PPPL NONCONFORMANCE REPORT NO: 3735    Open Date 11/15/07    Rev #: 1 , 12/20/2007

Status	1 - Eng Dept Head Concur Required	Trend	05-Design Interference
Department	NCSX	Division	WBS 142
Source/Org	Fabrication, Operations & Maintenance		
Item Dwg/Part#	b1_mtm_data_check.asm	Procurement #	WPF-1224
Cost Center	WBS/Other	00/00/00	
RAP#	3304	Job Doc #	WPF-1224
		Vendor	
RAP Title	Coil to Coil Assembly Trials

Review of “B1” to “C1” interface  
Response to NCR 3735  
and  
Deviation Request to Address  
Remaining B-C Coil Interfaces

Portion of master machine model identified as "b1\_mtm\_data\_check.asm" which brings together the top level MC assemblies, sel41-102 and -103 which include the MC Type-B and Type-C details.

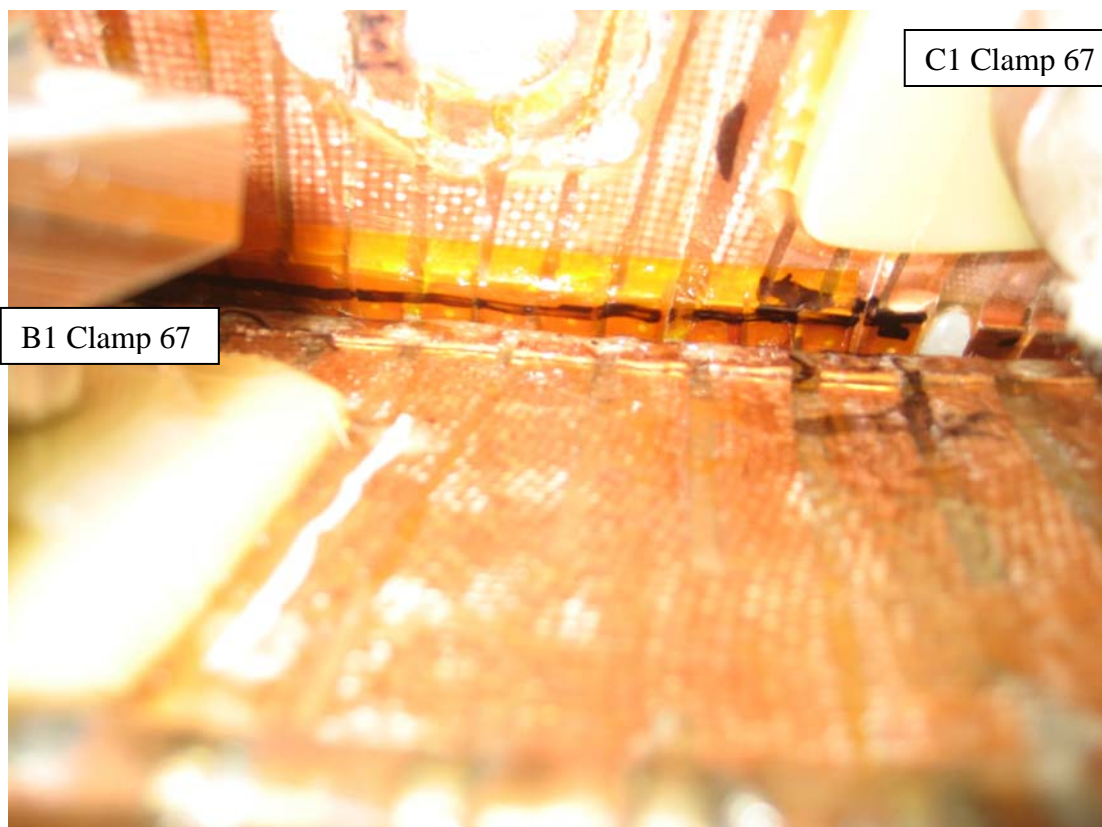
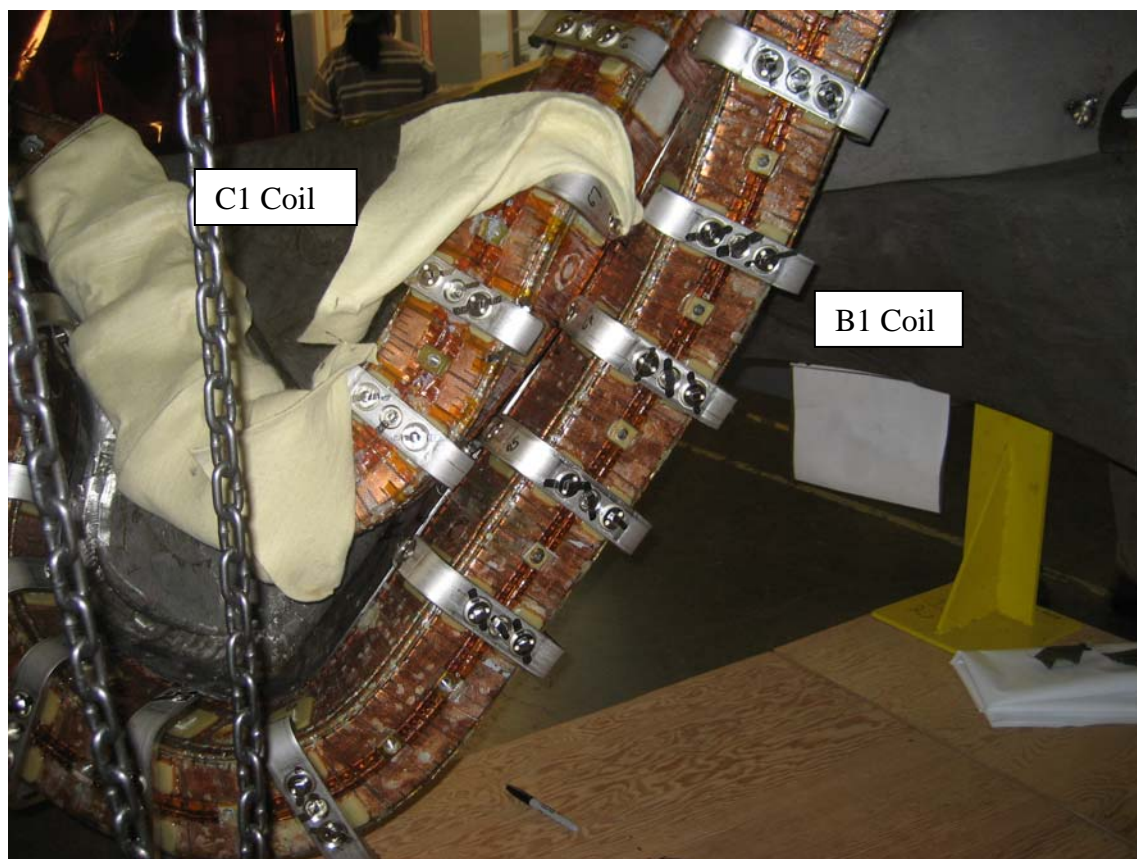
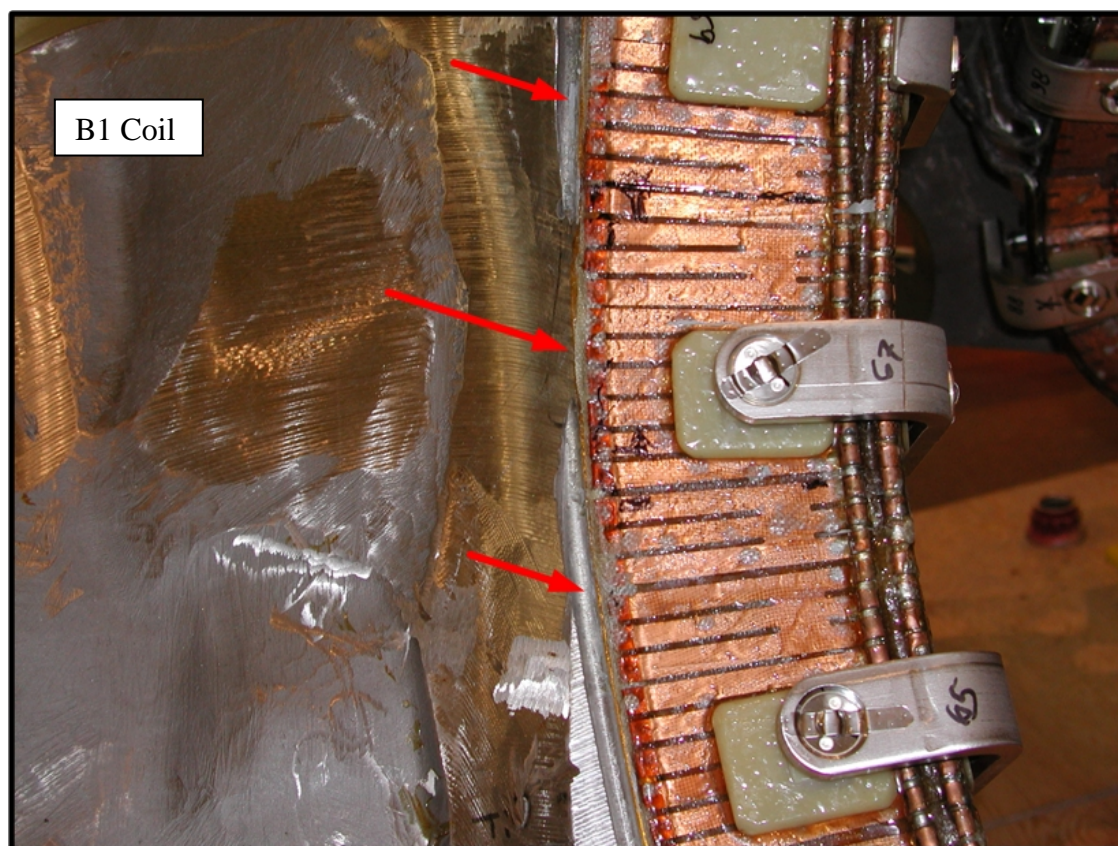
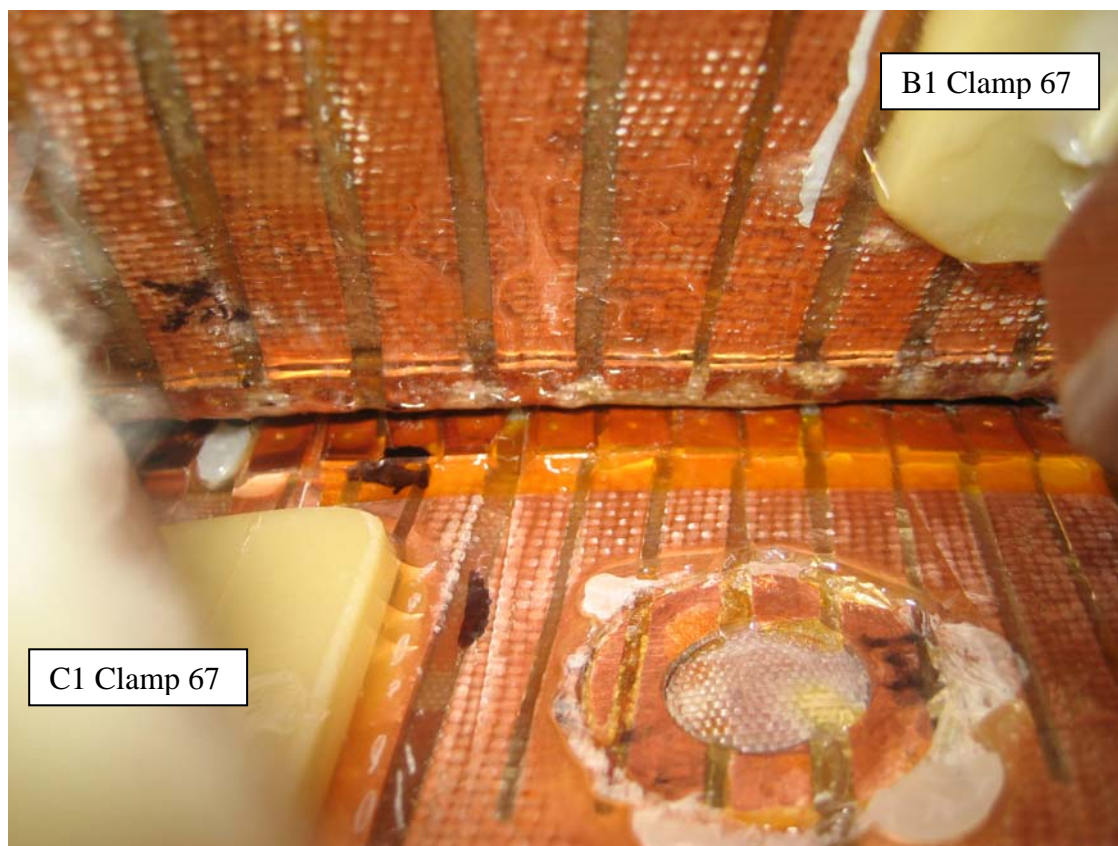
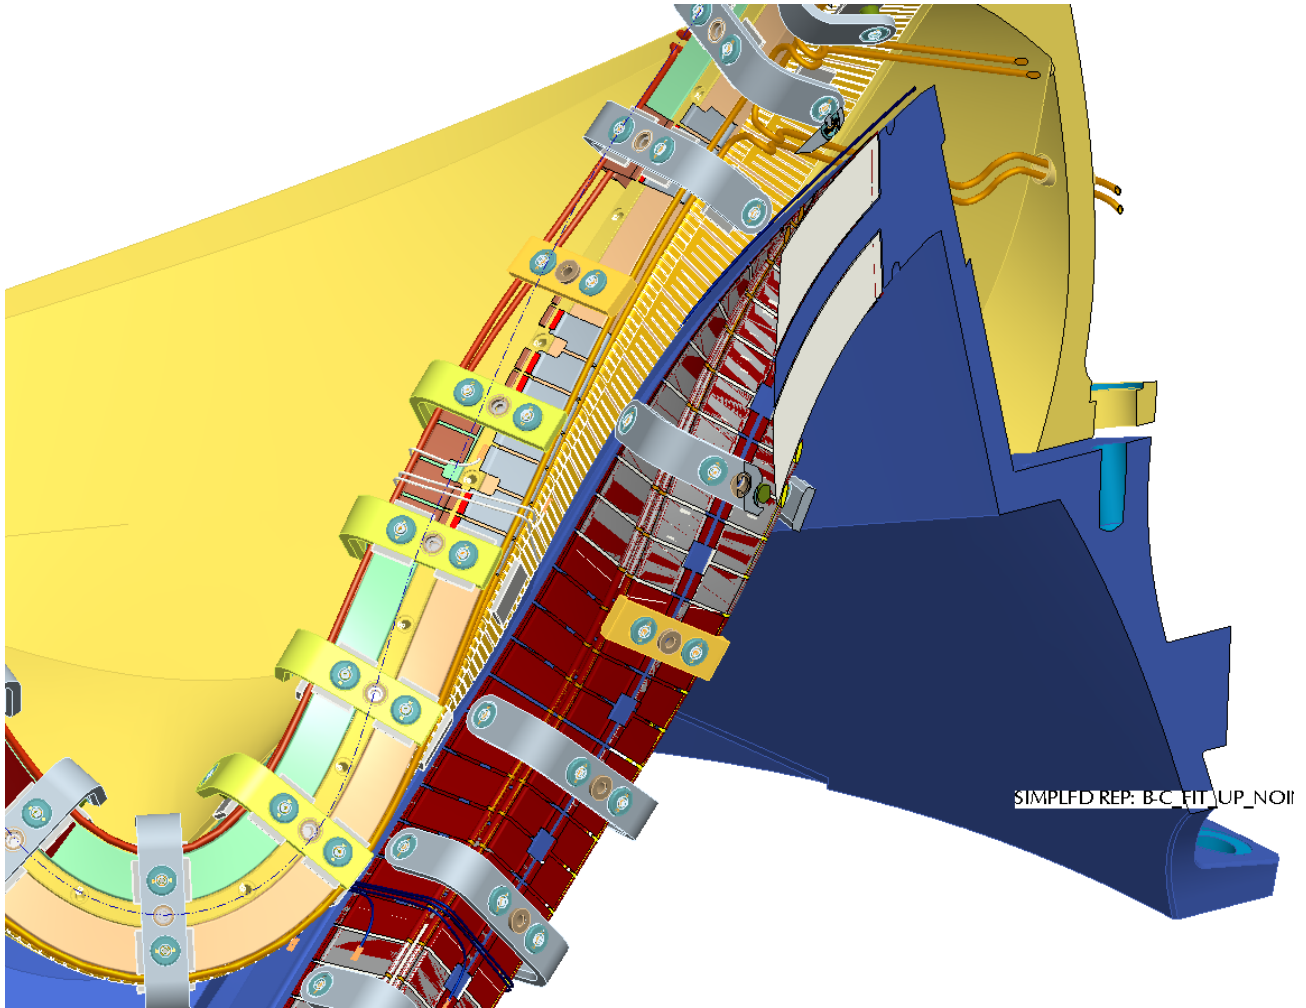
MCWF B1 & C1; During the trial fit-up of the B1 and C1 NCSX modular coils an interference was discovered in the vicinity of winding clamp #67. The interference is between the copper chill plates of each coil just above the VPI groove where the vertical chill plates are attached to the horizontal or base cladding, see attachment 1 for details.

- Modify the copper cladding on B1 and C1 as shown on page 3.
  - The slides which follow this are given for reference.
- Resolve interference between MCWFs as shown in the following slide set, and as detailed in the grinding table shown on slide 17.
- Verify clearance as given below (Requirement on clearance).

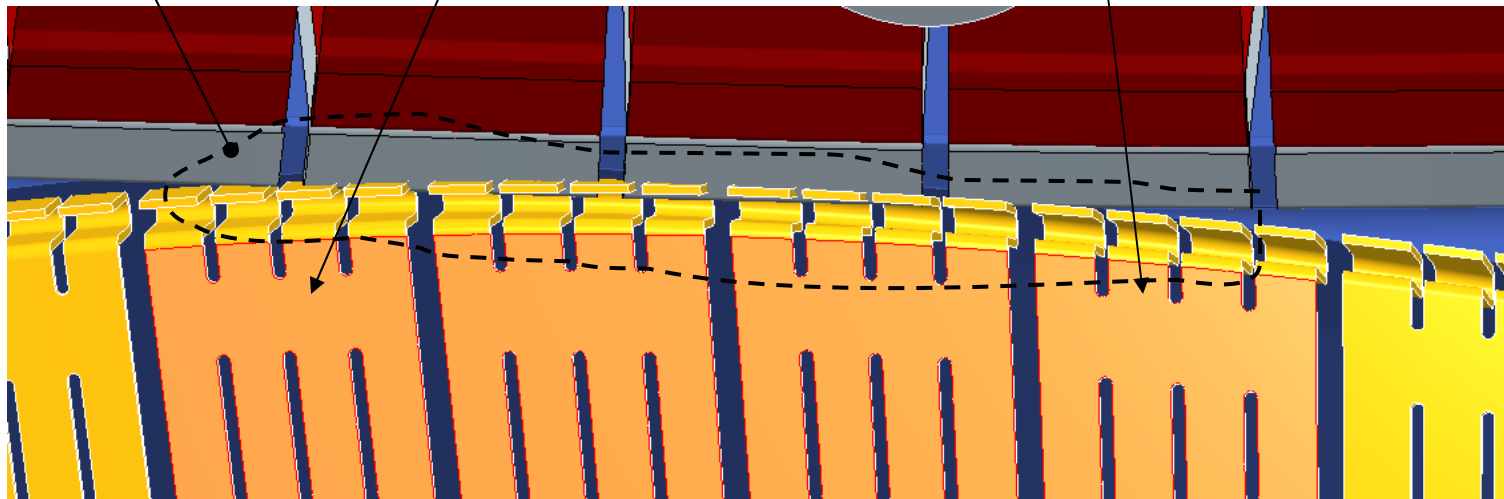
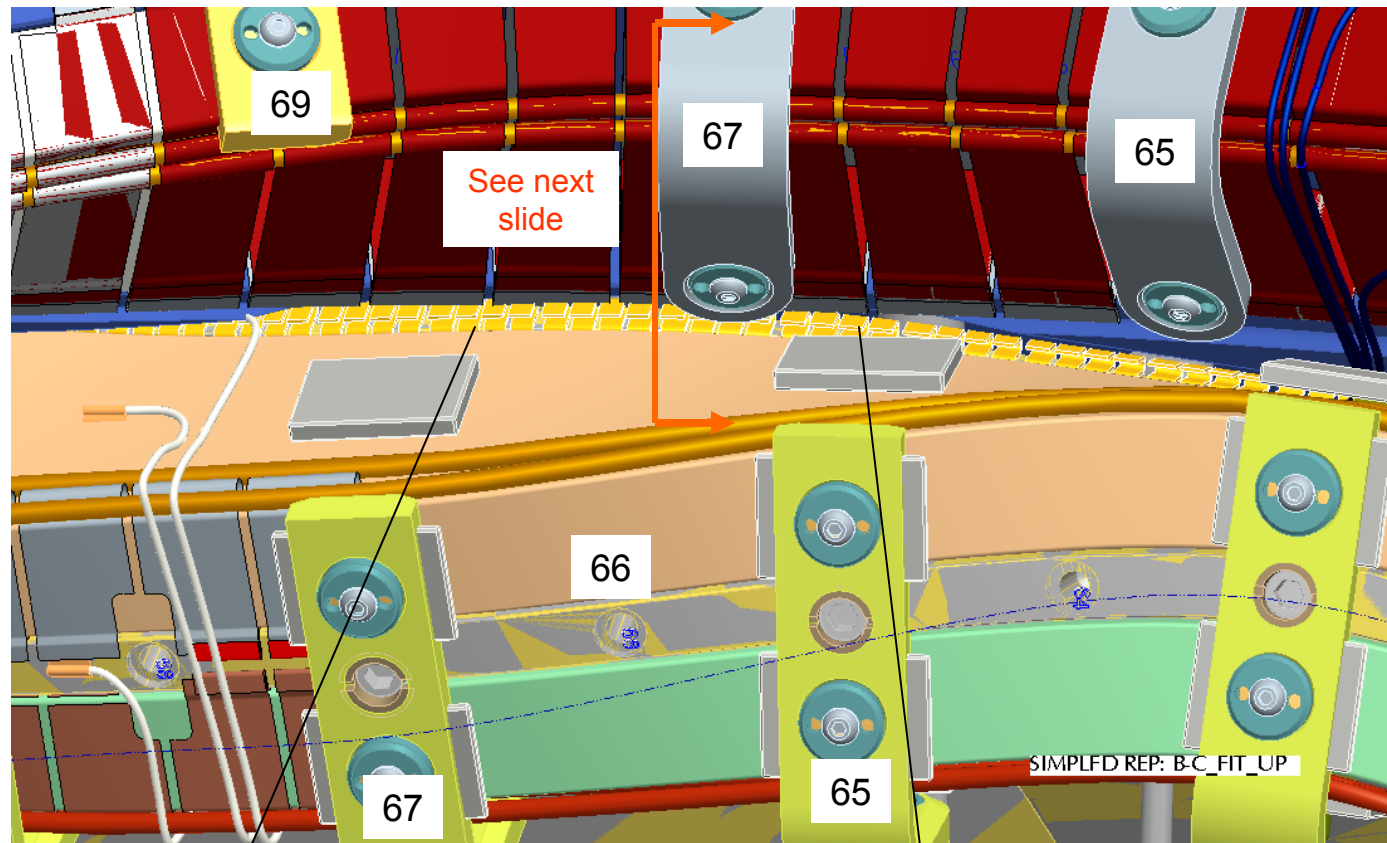
The “B” and/or  
“C” cladding in  
this area needs  
to be cut back.

# Plot comparisons (1/2 tabs connected) (K.

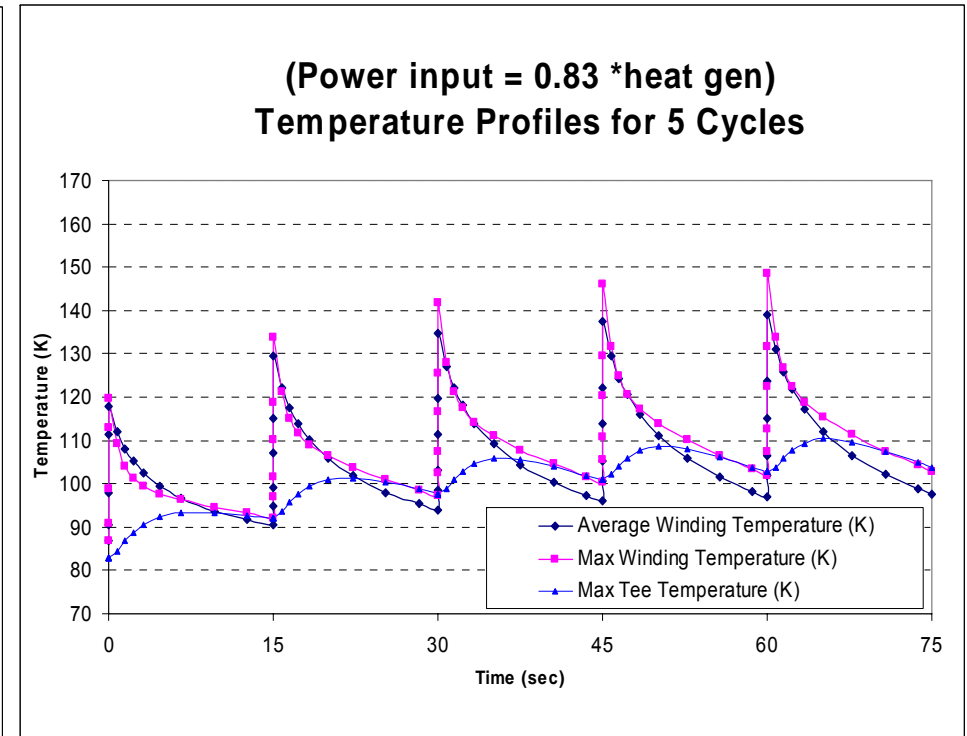
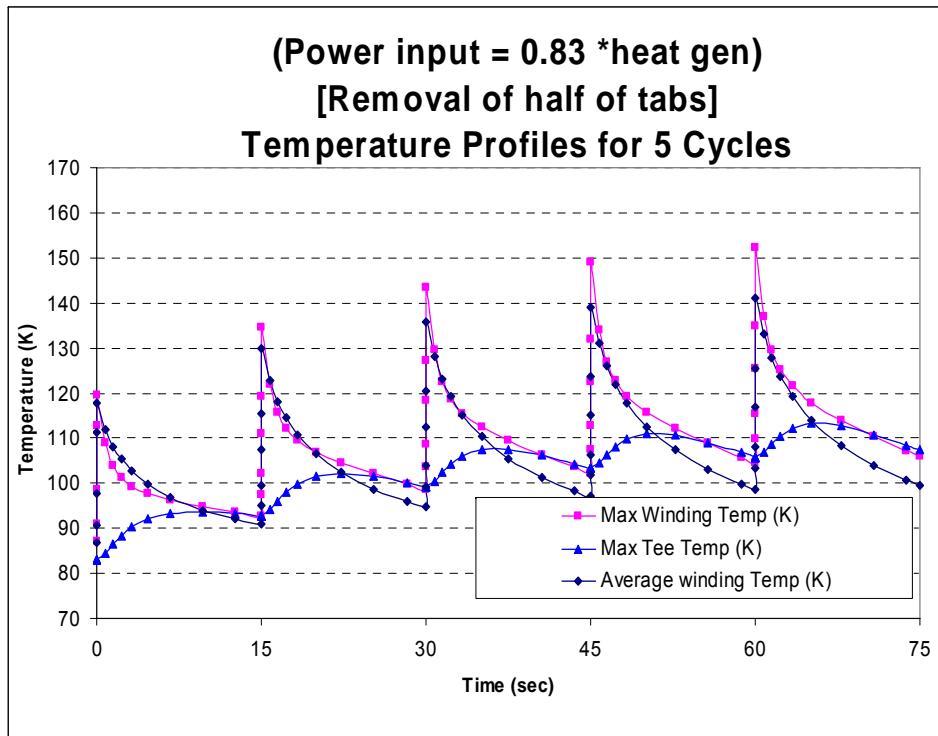
Very little change (2 degrees max)

**Pts 3 thru 10**

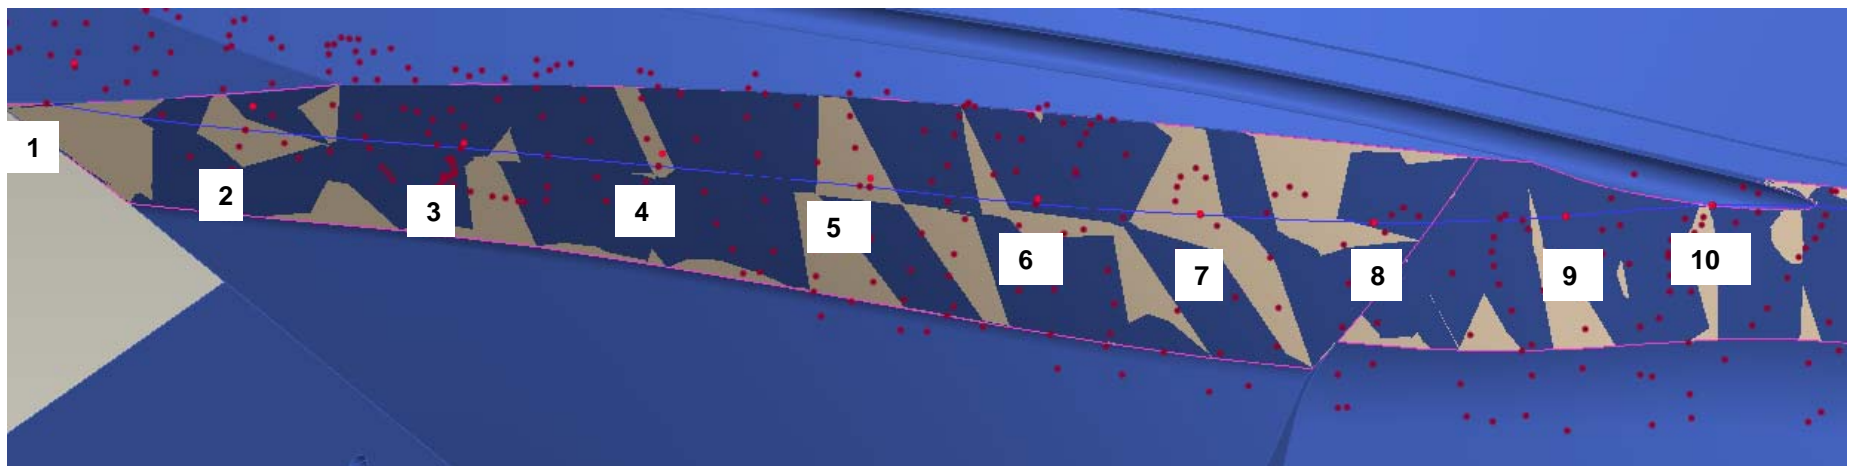
Point data relative to the "B" default coordinate system FOR B1 AND C1								
	X	Y	Z	"B" surf to "C" cladding	Curnt. Ground Dist. from Met. Pts	Curnt "B" surf to "C" cladding	Additional grinding depth for 1/4" gap	Added fractional grinding depth
1	34.087	-27.853	-41.520	0.046	0.649	0.695		none
2	34.532	-26.814	-39.870	0.046	0.361	0.407		none
3	34.997	-25.567	-38.164	0.046	0.092	0.138	0.112	1/8
4	35.353	-24.380	-36.598	0.046	0.162	0.208	0.042	1/8
5	35.686	-23.086	-34.925	0.046	0.128	0.174	0.076	1/8
6	35.952	-22.079	-33.603	0.046	0.094	0.140	0.110	1/8
7	36.251	-21.049	-32.331	0.046	0.020	0.066	0.184	3/16
8	36.651	-20.010	-31.011	0.046	-0.014	0.032	0.218	1/4
9	37.241	-18.809	-29.617	0.046	0.009	0.055	0.195	1/4
10	37.769	-17.908	-28.587	0.046	0.048	0.094	0.156	3/16
11	38.350	-16.817	-27.066	0.046	0.022	0.068	0.182	3/16
12	38.650	-16.047	-25.906	0.046	0.058	0.104	0.146	3/16
13	39.070	-14.208	-22.898	0.046	0.093	0.139	0.111	3/16

14	39.163	-13.659	-22.105	0.046	0.063	0.109	0.141	3/16

- **Requirement on clearance:** There shall be a minimum of 1/16” clearance between the winding forms and cladding in the as-assembled position. This clearance must be verified by actual fit-up of the mating winding forms, by either clay method or feeler gauges.
